Village of Arlington Heights
Plan Commission
Board Room, 3rd Floor
Arlington Heights Village Hall, 33 S. Arlington Heights Rd.
May 8, 2024
7:30 PM

Re: PC #23-012: Arlington Gateway – Phase I, Final Plat of Subdivision for Plan Commission Meeting on 5/8/24

Subject: PC 23-012 - Final Plat Review Request (Arlington Gateway)

Re: Arlington Gateway Development
Response to VAH Department Comments received 1 March 2024

SHEET NO.
1 of 3

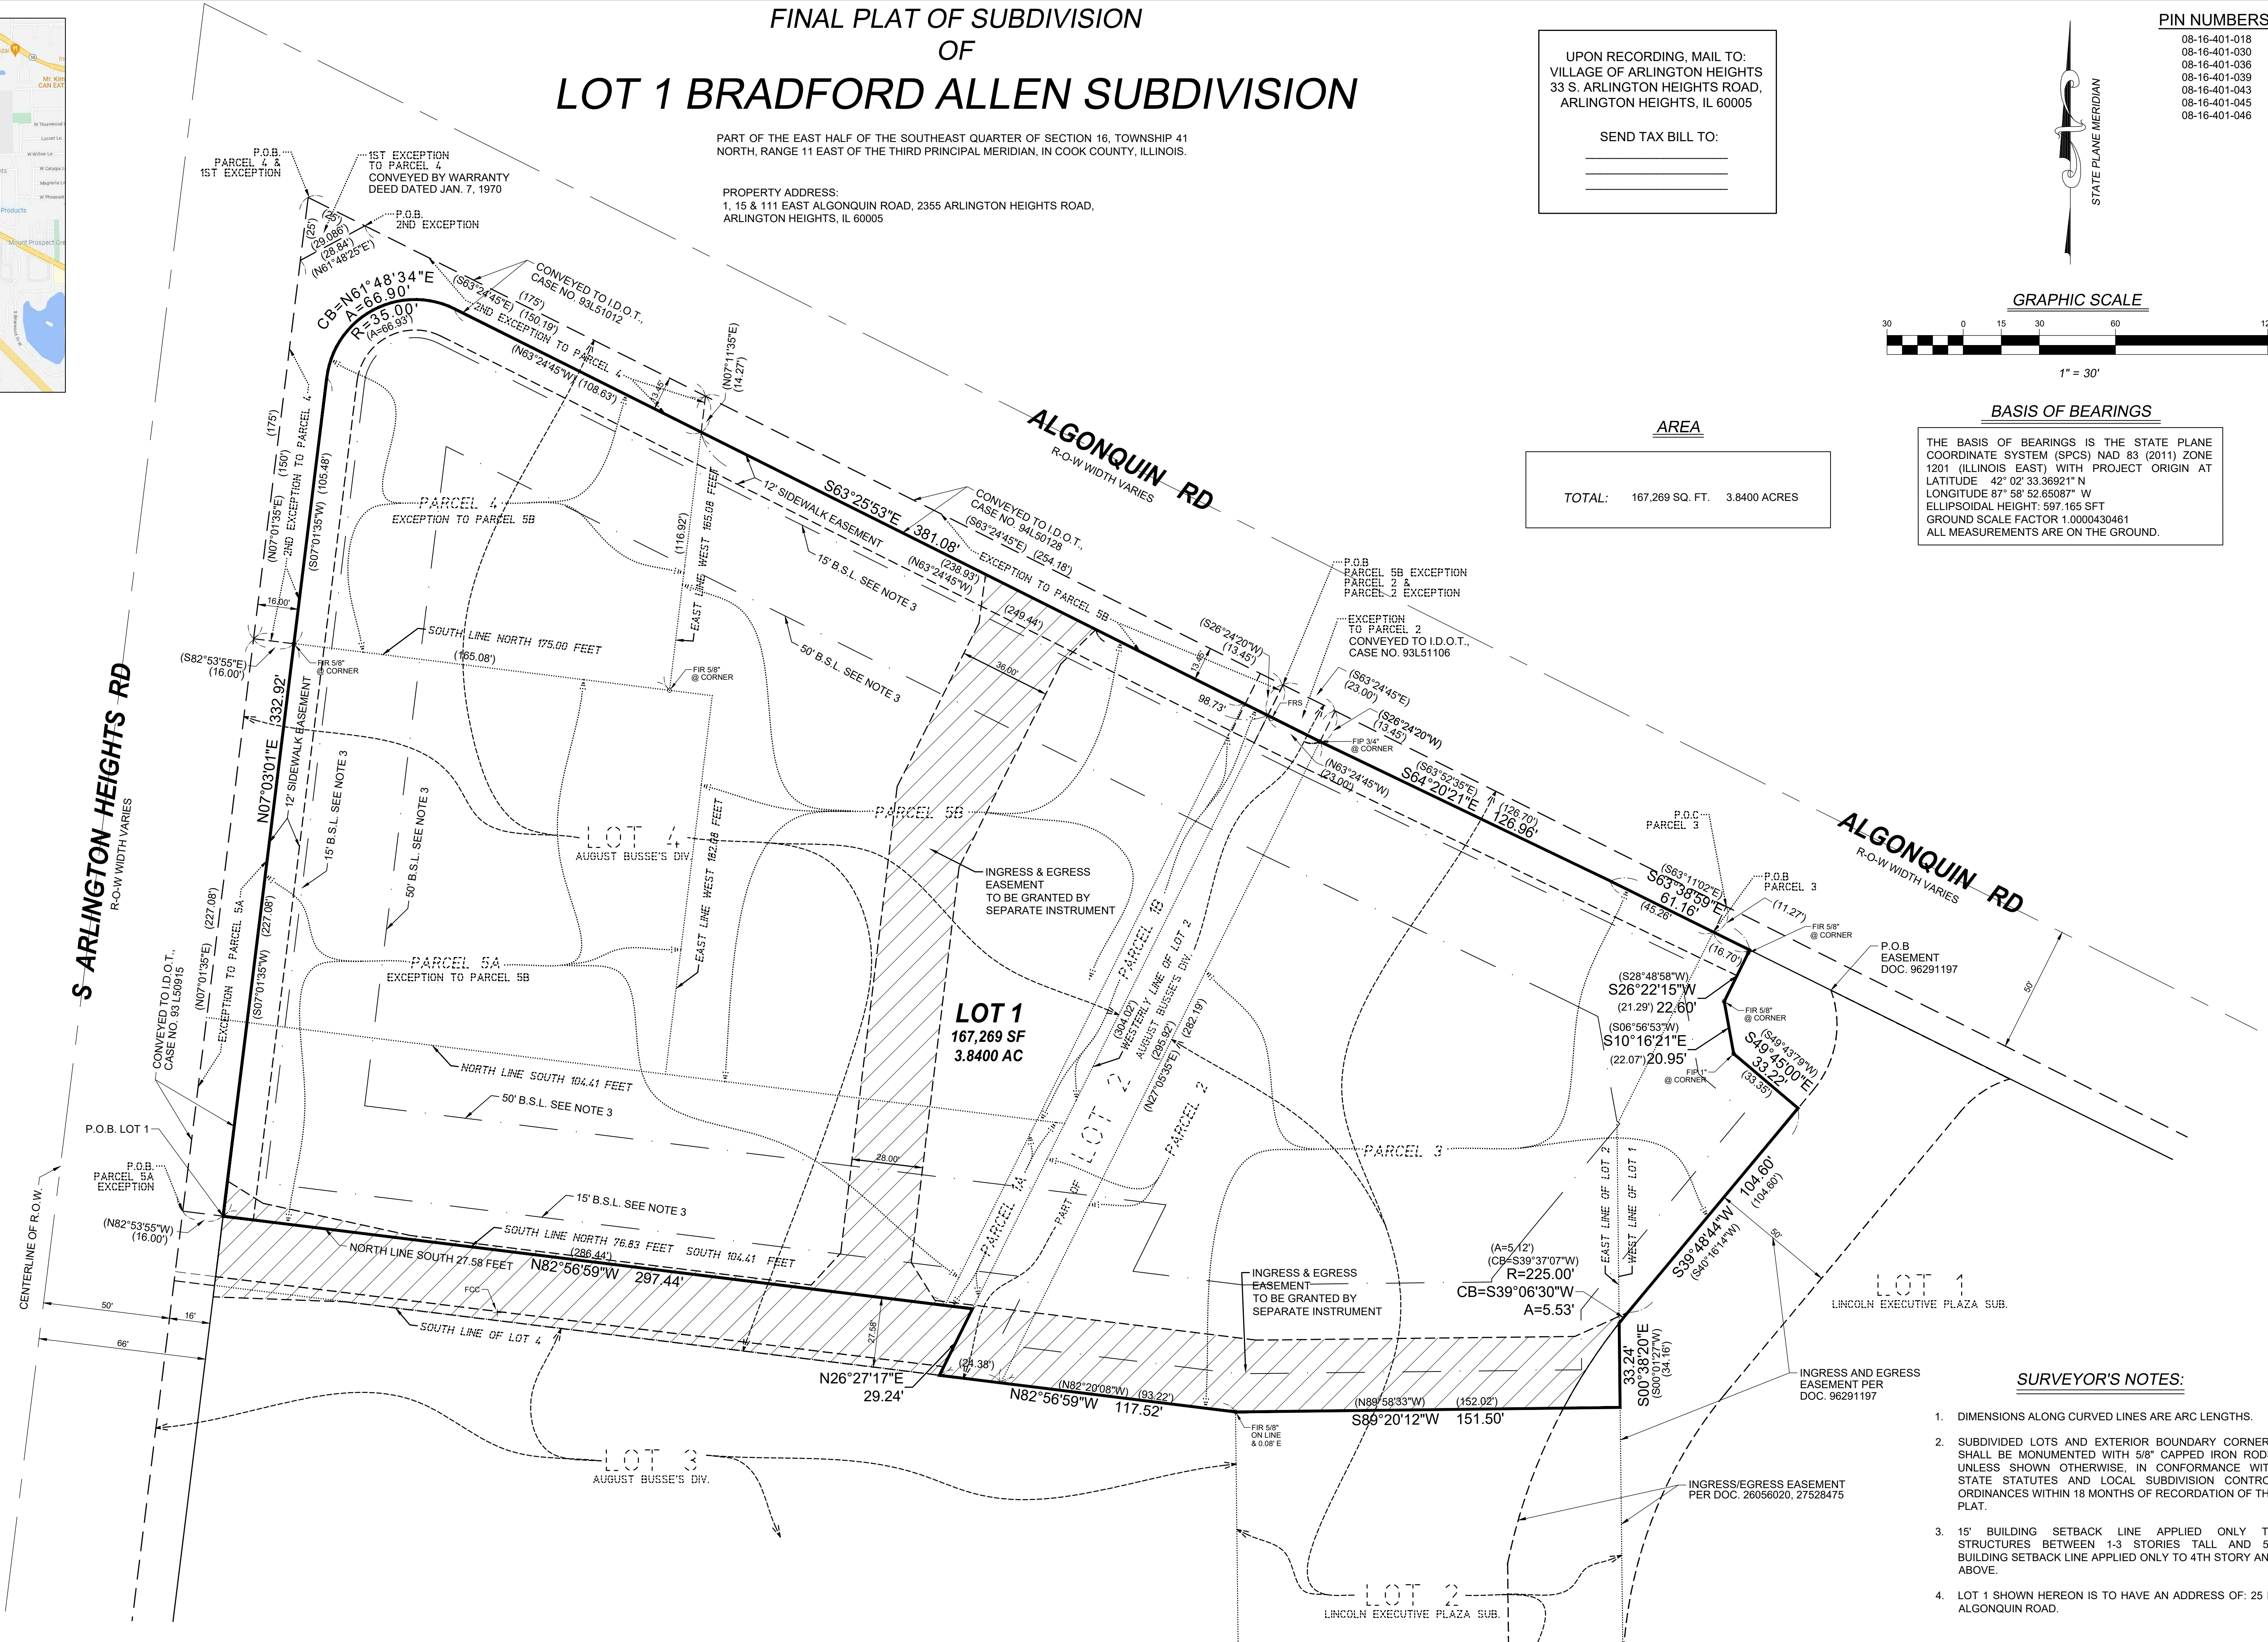
80. The Final Plat is labeled Preliminary Plat of Subdivision.
81. The petitioner's response to comment no. 67 is noted. The plat has not been revised and still shows the right-of-way to be 66 ft for Arlington Heights Road, the pavement width is approximately 124 ft. Verify the right-of-way width for Arlington Heights Road.
82. The petitioner's response to comment no. 51 is noted. The Final Plat has been reviewed for the Final Plat of Subdivision Checklist:
- a) Item u., provide a location to identify the address of each new lot. The address for Phase I building has been assigned the address of 25 E Algonquin Rd.

8. Please revise the plat to replace "Preliminary" with "Final".
9. There is a typo in the last paragraph of the legal description that describes "ALL OF THE ABOVE PARCELS". Please replace "Budde" with "Busse".
10. Please add to the Deed of Dedication the last paragraph as outlined in Section 29-217a of Chapter 29.
11. Signature lines shall be added to the Deed of Dedication.

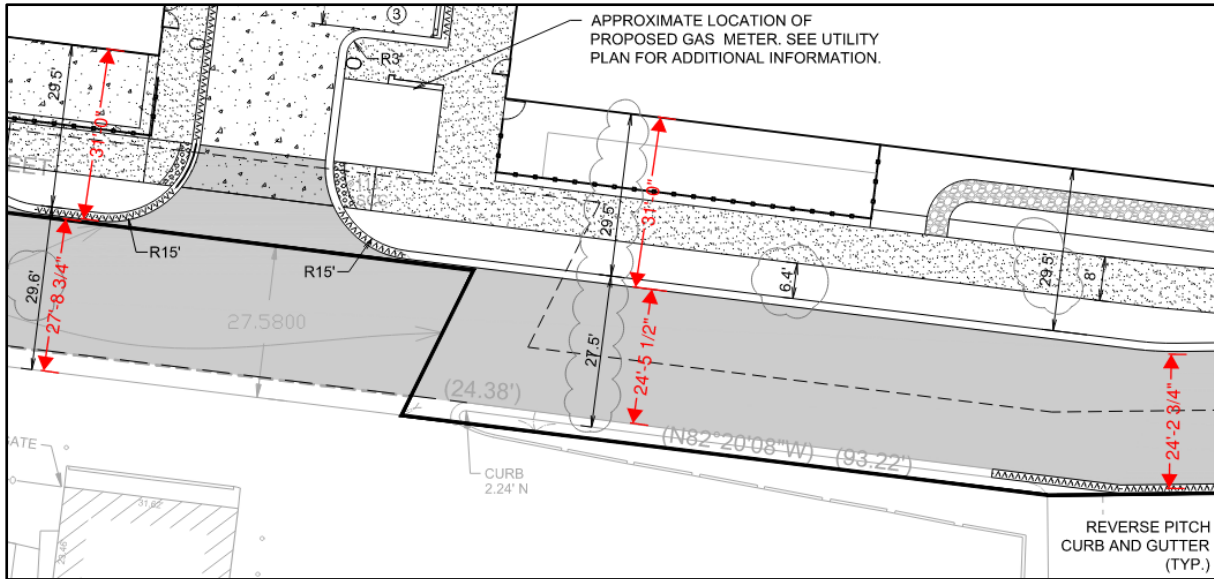
85. The petitioner's response to comment no. 72 regarding the fire exhibit and the dimensions to the building is noted.
- a) Update the exhibit to show the truck entering the site from eastbound Algonquin Road and entering the westerly parking lot.

- b) Update the exhibit to show the sweep of the basket and all extremities.

- c) The south aerial apparatus access road does not meet **sections D105.2 and D105.3 of the 2018 International Fire Code**: Aerial apparatus access roads shall have a minimum unobstructed width of 26 ft, exclusive of the shoulders, and shall be located not less than 15 ft and not greater than 30 ft from the building.

a) Update the exhibit to show the truck entering the site from eastbound Algonquin Road and entering the westerly parking lot. b) Update the exhibit to show the sweep of the basket and all extremities. c) The south aerial apparatus access road does not meet sections D105.2 and D105.3 of the 2018 International Fire Code: Aerial apparatus access roads shall have a minimum unobstructed width of 26 ft, exclusive of the shoulders, and shall be located not less than 15 ft and not greater than 30 ft from the building.	c) <i>The location of the aerial apparatus road has been shifted north so that the edge of pavement is located no greater than 30 ft from the building face.</i>
86	The petitioner's response to comment no. 73 on a Logistics Plan addressing access for the Guitar Center site is noted. The access road and the entrance to the Guitar Center is to be reconstructed which will impact access to Guitar Center if the business is to remain open. The Village is aware that the applicant is currently under contract to purchase the Guitar Center site. If access to the site is needed for the business, this can be addressed at permit.	<i>Noted. Guitar Center site is now under ownership of the same owner of our site. See attached Guitar Center Deed. We are implementing the logistics plan.</i>

Final Plat of Subdivision:

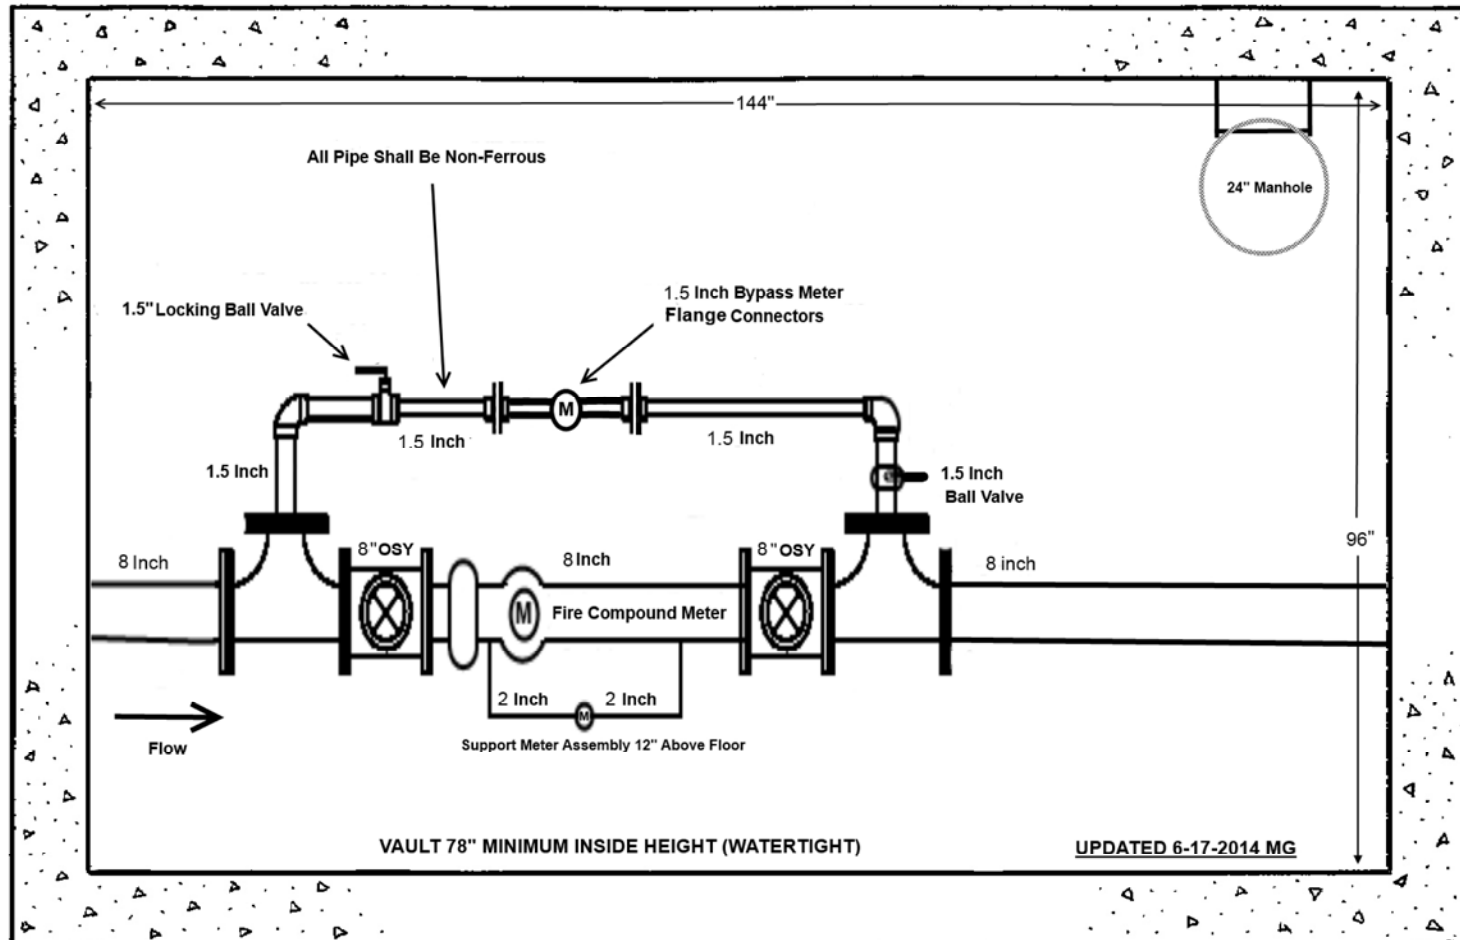
89. The proposed private utilities for Lot 1 are located within the ingress/egress easement on the Guitar Center site. A private utility easement shall be established.

95	The petitioner's response to comment no. 89 is noted. Since the adjacent Guitar Center property is now under the ownership of the petitioner, the required private utility easement can be provided either on the Final Plat of Subdivision or as a separate document.	<i>Please see attached exhibit 16 "Easement Agreement Lot 1 and Guitar Center v2"</i>
----	--	---
